CITY COUNCIL MEETING STAFF REPORT

DATE OF MEETING: January 21, 2025
NAME OF PROJECT: Southhill
NAME OF APPLICANT: Midway Heritage Development, LLC
AUTHORIZED REPRESENTATIVE: Daniel Luster
AGENDA ITEM: Southhill Phase 3 Preliminary Approval and Conditional Use Permit
LOCATION OF ITEM: 541 East Main Street
ZONING DESIGNATION: C-2

Subject: Southhill Phase 3 PUD – Preliminary Review

LUSTER
 SOUTHILL - PHASE 3
PRELIMINARY DITCH PLAN

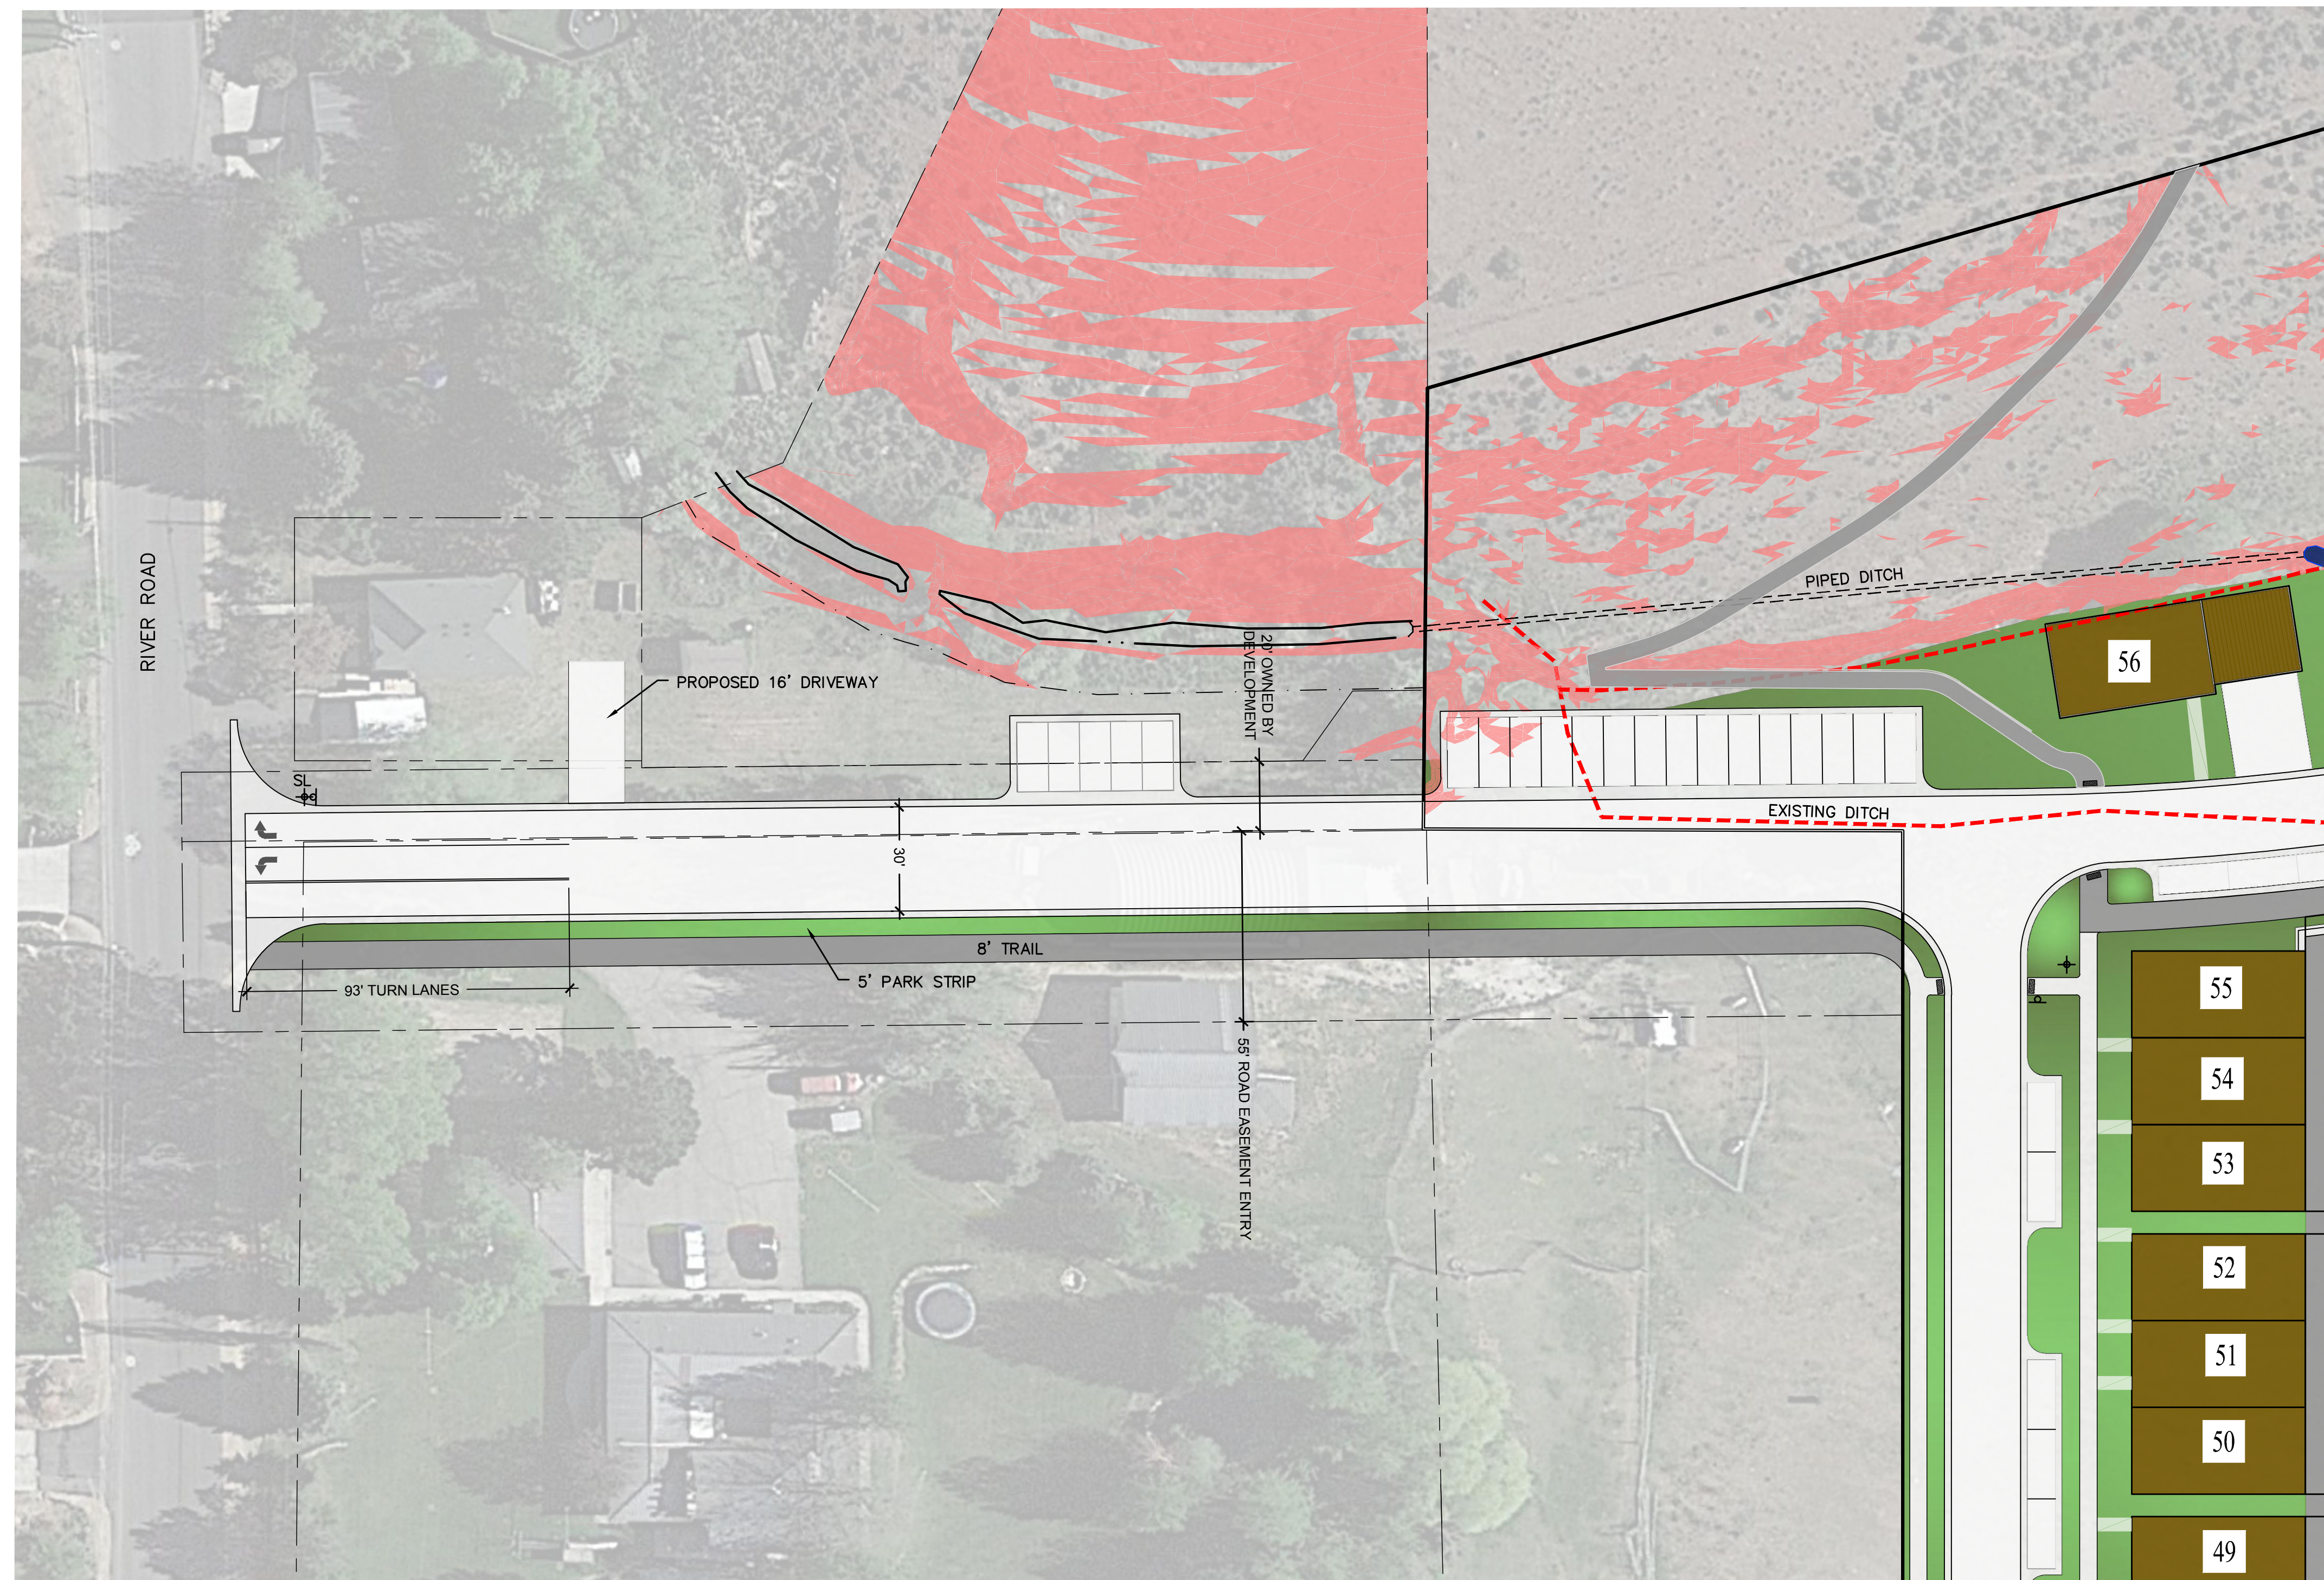
Midway Irrigation Company Ditch – There is an existing Midway Irrigation Company ditch that runs west to east across the property. The proposal is to reroute the ditch through parts of phases 3, 4, and 5. Midway Irrigation Company will need to review the plans and approve them before the ditch can be relocated.

- The subdivision will be serviced by the Midway Irrigation Company.
- All removal, additions, or revisions to the pressurized irrigation system must be approved by the Midway Irrigation Company.
- There is a ditch towards the north end of the property that flows west to east. The ditch is proposed to be placed in a network of culverts and open ditch as it flows under driveways to the east side of the development. All proposed work on this ditch must be approved by the Midway Irrigation Company.

LUSTER
SOUTHILL - PHASE 3
RIVER ROAD ACCESS PLAN

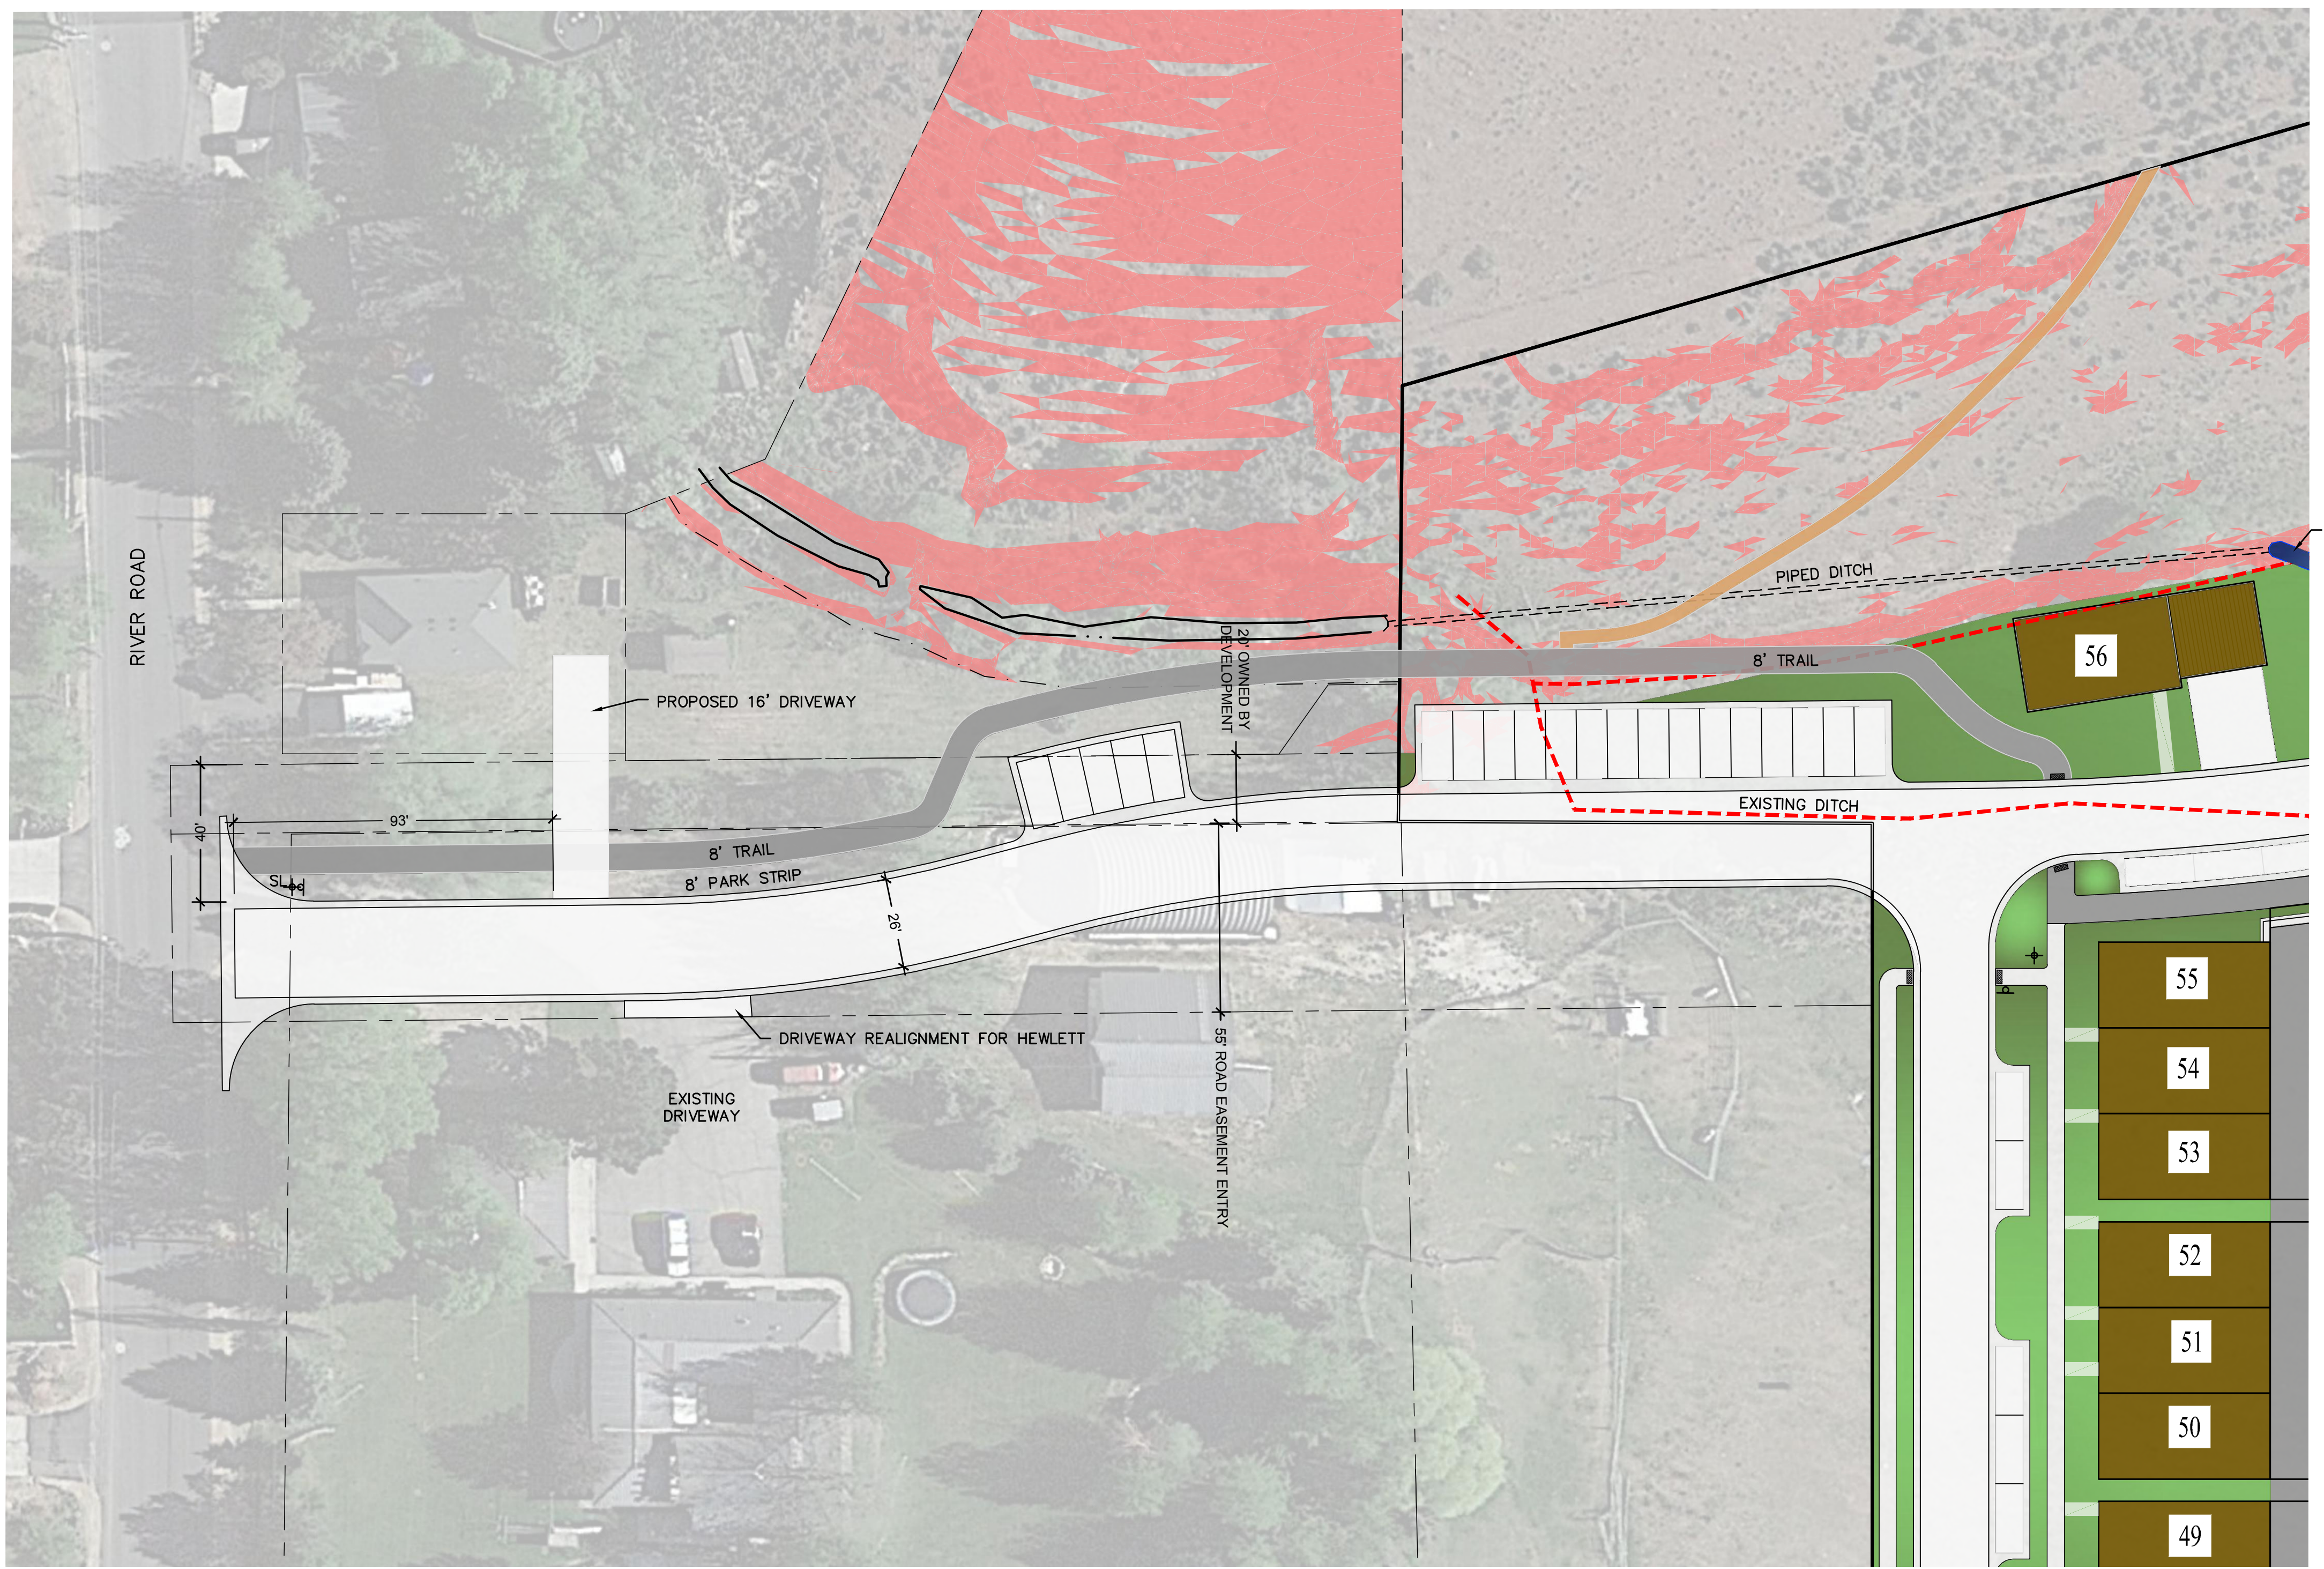
Intersection and Driveway Location – The proposed River Road access and the property directly north of it (OMI-0418-0, River Road Midway LLC) will have access points that are within 40’ of each other based on some of the plan submitted in the application. Driveways and intersections should be separated by 40’ to avoid safety issues of them being too close together. One way that the applicant has addressed this issue by allowing access to OMI-0418-0 to be directly from the proposed River Road access. Once driveway access is moved from OMI-0418-0 to the proposed road access then the existing driveway to River Road will need to be abandoned. Staff is requiring that written acknowledgement from the owner of OMI-0418-0 if this option is chosen to assure that the existing driveway will be abandoned once the proposed road is constructed. The other option is to move the proposed road 40’ from the existing driveway. Drawings have been submitted to the City for both options.

- The proposed roads and sidewalks within the development will be private with public access.
- An outlet to River Road will provide a dedicated left and right hand turn lane
- The timing of the traffic signal at the intersection of Main Street and River Road shall be per the master plan agreement.
